# Sheringham Shoal and Dudgeon Offshore Wind Farm Extension Projects

Addendum to the Flood Risk Assessment (Revision B)  
(Tracked)

## Revision B

Document Reference: 14.31.1

Figure 1: 1 in 100 year plus 45% for climate change with OnSS platform level set at 28.23m AOD and NW access road

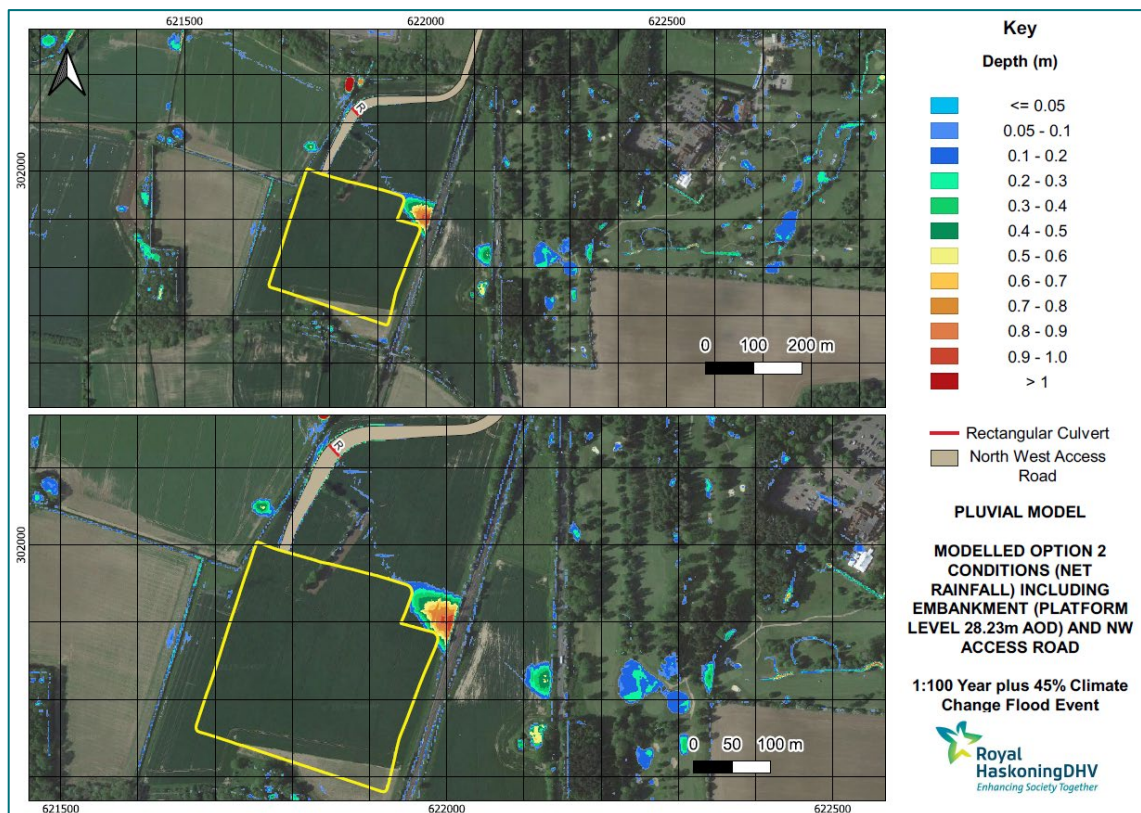
- ~~60-62.~~ Comments were provided by the LLFA in their **Relevant Representation** [RR-064] with specific regard to the requirement for an update to the surface water hydraulic model for the Onshore Substation such that it applies the latest climate change allowances and provides an assessment of the change in flood risk.

- ~~61-63.~~ As noted previously, a meeting was held with the LLFA on 6<sup>th</sup> December 2022 to obtain clarification on the required changes and updates. This included confirmation that in the absence of information related to the Decommissioning Phase an allowance of 45% for climate change should be applied. Revised hydraulic model scenarios have therefore been undertaken and presented in the updated **Annex 18.2.2: Onshore Substation Hydraulic Modelling Report (Revision B)** [document reference ~~14.34~~~~6.3.18.2.2~~].

- ~~64-67.~~ Figure 9-23 of the **Annex 18.2.2: Onshore Substation Hydraulic Modelling Report (Revision B)** [document reference ~~14.34~~~~6.3.18.2.2~~] is reproduced below as **Figure 1**. The results from this modelling scenario demonstrate there is minimal interaction between the Onshore Substation platform and North West (NW) access road and the surface water flood extent during the 1 in 100 year plus 45% climate change allowance event.

- ~~65-68.~~ The results also confirm that whilst the flood depth adjacent to the Onshore Substation platform varies, it is not of a sufficient depth to result in flooding to the Onshore Substation platform. In addition, it confirms that the NW access road can be designed such that there is continued conveyance beneath it.

- ~~66-69.~~ On this basis neither the Onshore Substation platform nor the NW access road will result in flooding to SEP and DEP. Furthermore, they will not result in displacement of surface water flooding such that there would be an off-site impact on surface water flood risk.

Figure 2: 1 in 100 year plus 45% for climate change comparison of changes in flood extent

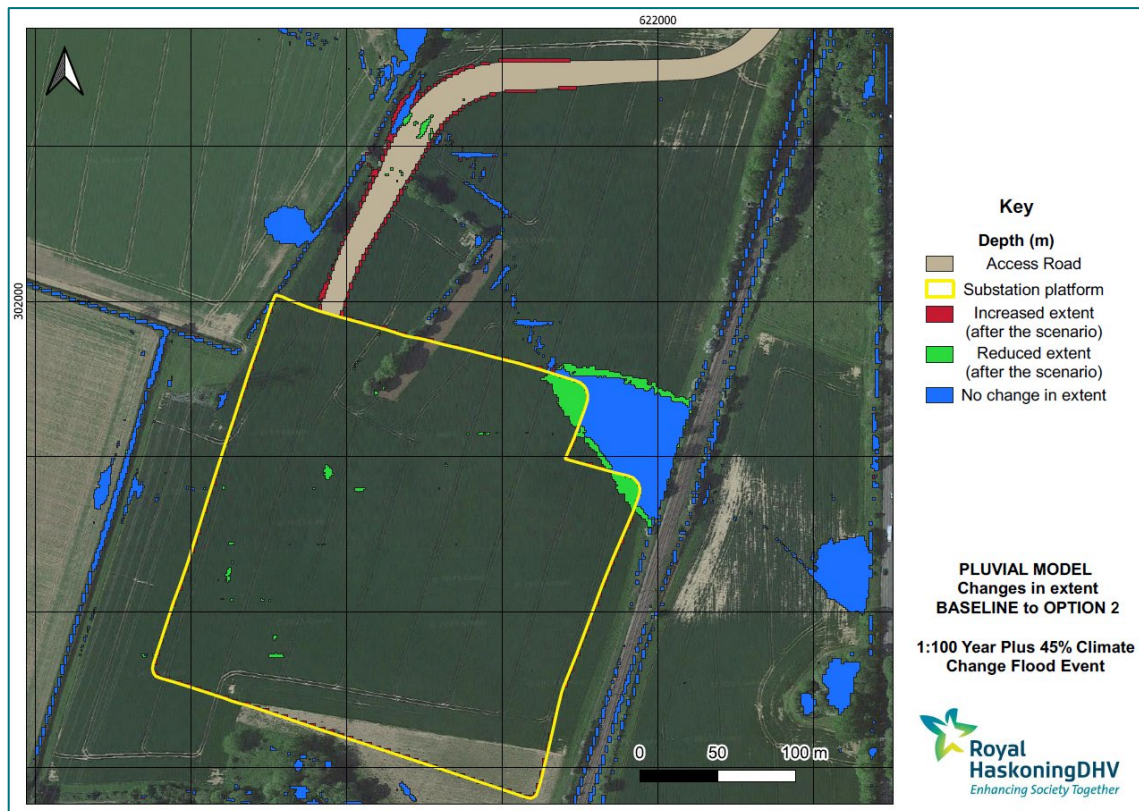
- 67.70. In addition, to demonstrate there is no off-site impact as a result of SEP and DEP, a comparison of the Baseline scenario has been undertaken with the Post Construction (i.e. operational) scenario.

- 68.71. To demonstrate the change in maximum flood extent and depth, the 'Option 2 with Embankment and North West access road' results grid was subtracted from the 'Baseline' modelling results grid. This was to ensure the difference in flood extents and depths could be depicted more clearly. This exercise was undertaken for the 'worst case' scenario comprising the 1 in 100 year plus 45% for climate change allowance event.

- 69.72. Figure 9-24 of the **Annex 18.2.2: Onshore Substation Hydraulic Modelling Report (Revision B)** [document reference [14.346.3.18.2.2](#)] is reproduced below as **Figure 2** and demonstrates the change in flood extent following the construction of the Onshore Substation platform and NW access road.

- 70:73.** While there is a reduction in the flood extent around the edge and within the footprint of the Onshore Substation platform, the results of the modelling indicate there is a slight change to the flood extent along the edges of the raised NW access road.

- 74:74.** The reduction in flood extent can be attributed to the incorporation of the Onshore Substation platform within the model. By including it within the model, rainfall falling on the platform during an event does not contribute to the flooding as water from the impermeable or bound surfaces this will either be collected by the surface water drainage system to be implemented as part of SEP and DEP whilst or the permeable or unbound areas will naturally infiltrate into the ground on the platform or adjacent to the NW access road.

- 72:75.** A review of the results has confirmed the change in extent adjacent to the NW access road is very localised and does not extend beyond the immediate area and is related to a minor accumulation of surface water adjacent to the access road structure.

- 76.** Upon review of this data, it is noted that the change in extent along the edges of the NW access road is a result of its representation within the model whereby surface water from the impermeable or bound surface of the access road is draining off the sides. However, the proposed drainage design for the Onshore Substation platform would capture this water within the surface water drainage system and therefore this flow would not exist.

- 77.** It is also noted that there is no restriction of flow as a culvert below the NW access road has been included within the model. This is confirmed in Annex 18.2.2: Onshore Substation Hydraulic Modelling Report (Revision B) [document reference 14.34] which notes that the modelling included a 2.20m high culvert, primarily for modelling purposes. However, a review of the model results identified that during the 1 in 100 year (plus 45% for climate change) event the maximum water depth at the upstream extent of the culvert is likely to be approximately 0.23m. As such, a 2.20m high culvert would be considerably larger than that required to ensure the continued conveyance of surface water flow.

- 73.78.** On this basis, it is concluded that the height of the culvert can be refined and reduced during the detailed design process to provide cover levels of between 0.3m and 1m from the top of culvert to the access road carriageway. This would ensure sufficient cover levels, appropriate to the type and nature of the vehicle loading in this location, whilst also maintaining surface water flow conveyance under the access road.

Figure 3: 1 in 100 year plus 45% for climate change comparison of changes in flood depth

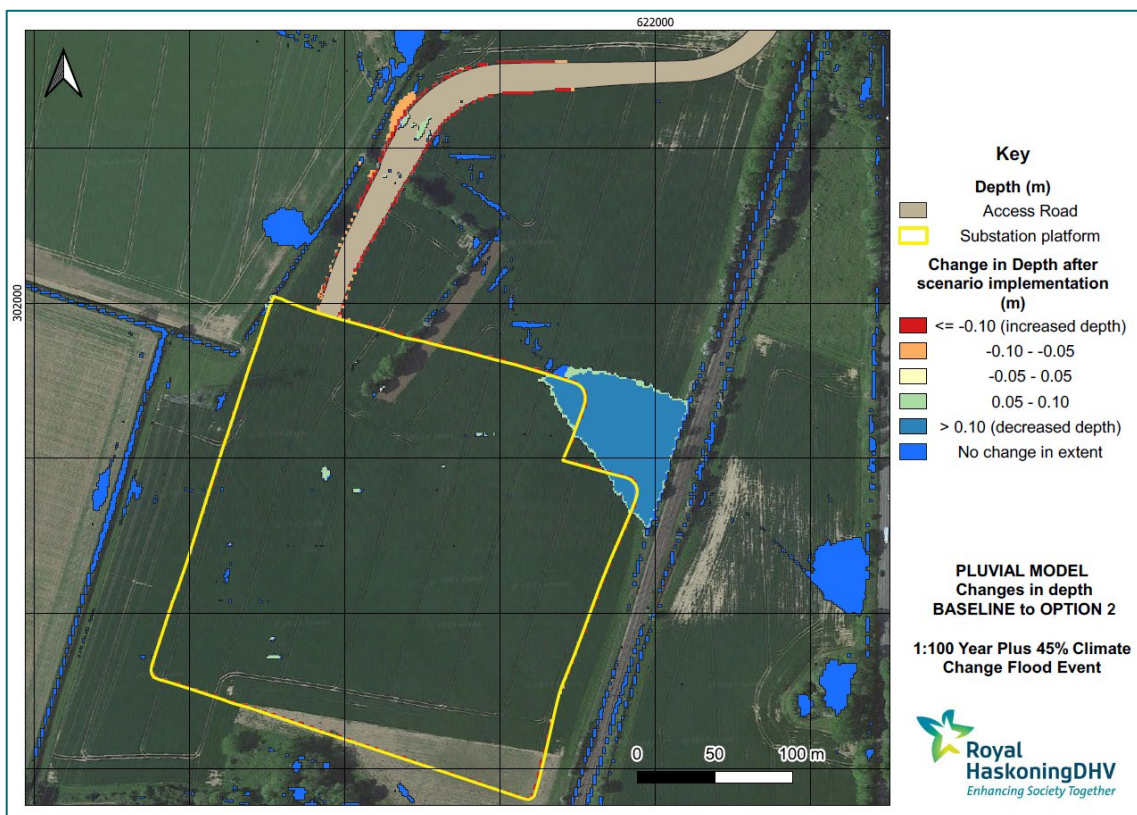
- 74.79.** To provide greater clarity on the impact of the Post Construction scenario on surface water flood risk, the changes in depth have also been considered.

- 75.80.** Figure 9-25 of the **Annex 18.2.2: Onshore Substation Hydraulic Modelling Report (Revision B)** [document reference 14.346.3.18.2.2] is reproduced below as **Figure 3**.

- ~~76~~.~~81~~. A comparison between the Baseline and Post Construction results demonstrates that any flood water which is displaced by the proposed Onshore Substation platform is relatively minor and will not result in a significant off-site risk. Furthermore, it also demonstrates there is a slight reduction in the depth of water pooling against the railway embankment.

- ~~77~~.~~82~~. As previously noted, this is likely to be due to the rainfall falling directly onto the Onshore Substation platform ~~either~~ being collected from the impermeable or bound surfaces by the surface water drainage system to be implemented as part of SEP and DEP whilst the permeable or unbound surfaces ~~or~~ will naturally infiltrate into the ground on the platform. Overall, t~~h~~is results in a reduction in ~~less~~ surface water reaching the low-lying area adjacent to the railway line.

- ~~78~~.~~83~~. The updated modelling exercise, incorporating the revised climate change allowances, does not result in a flood risk to SEP and DEP throughout the lifetime of the development.
